# Reevaluating Kosovo's Least Cost Electricity Option

Preliminary Evaluation of the World Bank's December, 2011 "Background Paper, Development and Evaluation of Power Supply Options for Kosovo"

Bruce C. Buckheit  
January 2012

**Prepared for:**  
Sierra Club  
The Kosovar Institute for Development Policy (INDEP)

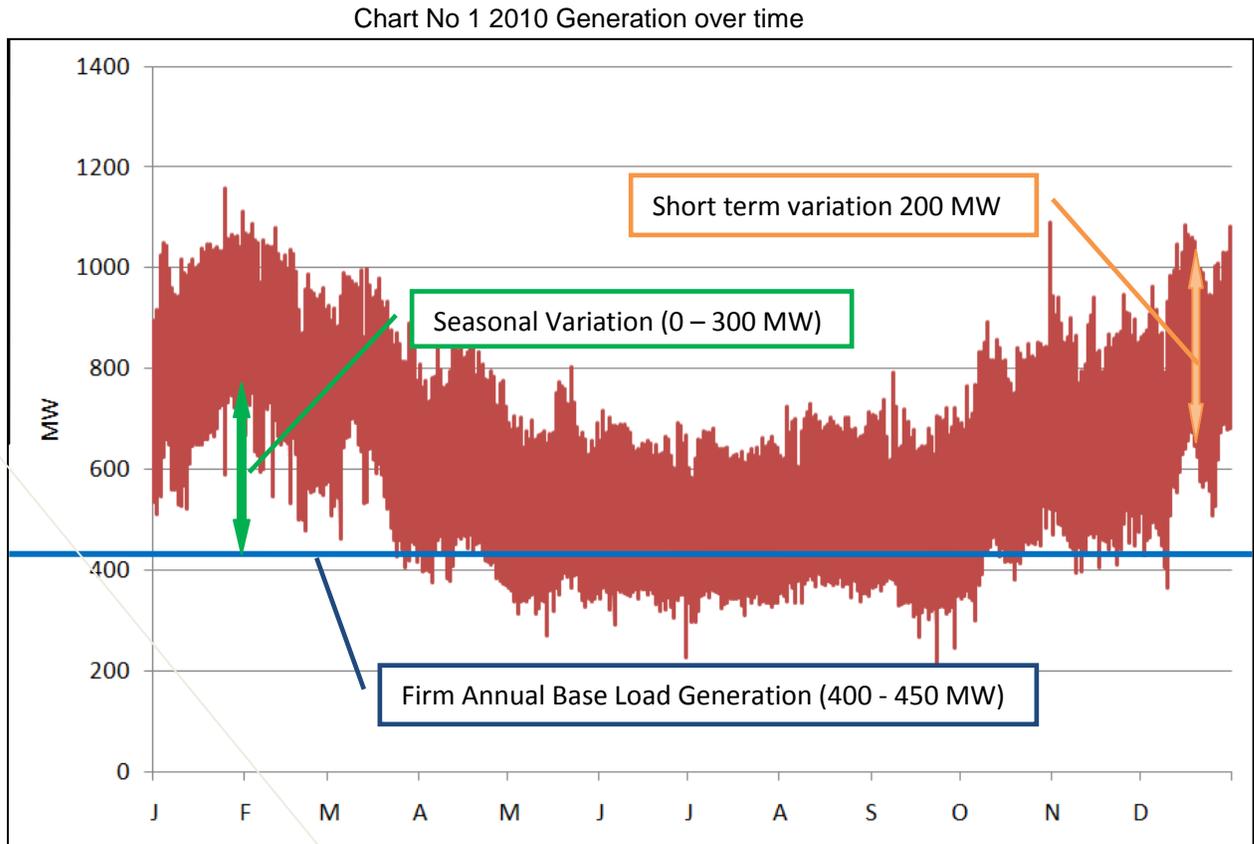
The WB Background Paper includes plots of electric consumption (including technical and nontechnical losses) for 2010. These plots are reproduced and annotated below.

Net consumption by consumers (residential and commercial) is reported in the WB Background Paper at 57 per cent of the amounts generated. Thus, the actual base load consumption (assuming no losses) in 2010 was met by 228 MW of generation. If the “distribution” losses are reduced from 17 percent to 5 percent and “commercial” losses similarly reduced from 24 percent to 5 percent (and assuming a price elasticity of -0.4) then net base load consumption rises by an equivalent of 11.4 MW (since those who had been getting “free” (i.e. stolen) or unmetered electricity would now pay for and consume 60 percent of the earlier amounts). However, net base load consumption rises to 80 per cent of firm base load net generation – and can be met by 320-340 MW of firm annual base load generation. Thus, if distribution and “commercial” losses are reduced to levels commonly experienced throughout the world, a refurbished Kosovo B (618 MW

net generation) could of supply almost twice the firm base load consumption as occurred in 2010.

Chart No. 2 Cumulative Generation

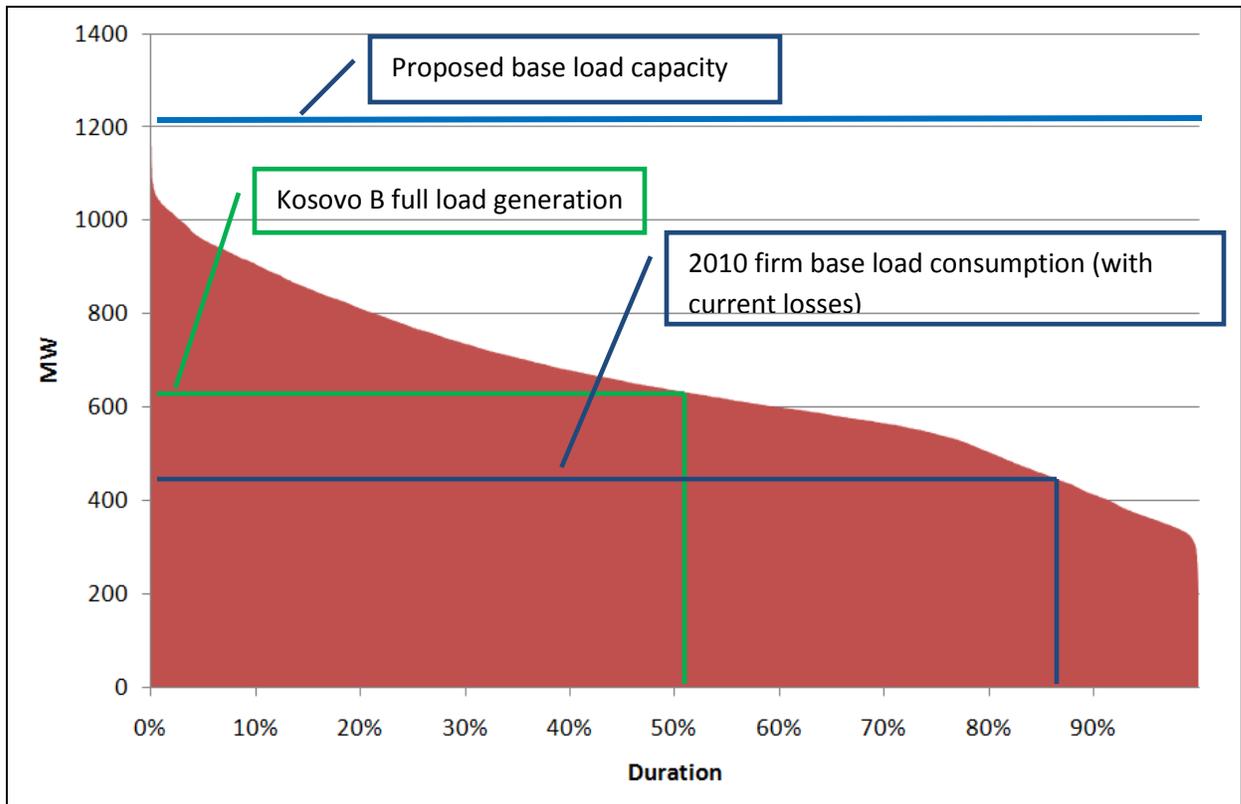
The data from Chart No. 2 shows that, with 2010 levels of technical losses and theft, the firm base load level<sup>6</sup> was slightly above 400 MW and that the generation needed to meet demand (and cover losses) would have required full load operation of a refurbished Kosovo B plant only 50 percent of the time. If technical and non-technical losses are each reduced to five percent, the values of the vertical axis of the chart are reduced by 20 percent.<sup>7</sup> The full base load need of the system is reduced to 340 MW and a refurbished Kosovo B plant would only need to operate at full load 20 percent of the time to meet this demand. If the full base load demand is assumed to grow by the high end suggested by the World Bank Background Paper (4.5 percent per annum), the

<sup>7</sup> Since it is reasonable to assume that the reduction in losses is uniform across the load profile the shape of the curve should not vary significantly, but simply be reduced such that, where the vertical axis in Chart 2 reads 400 MW, it would become 320 MW and where the vertical axis of the Chart reads 800 MW, it would become 640 MW. The proposed base load capacity would remain at 1200 MW.
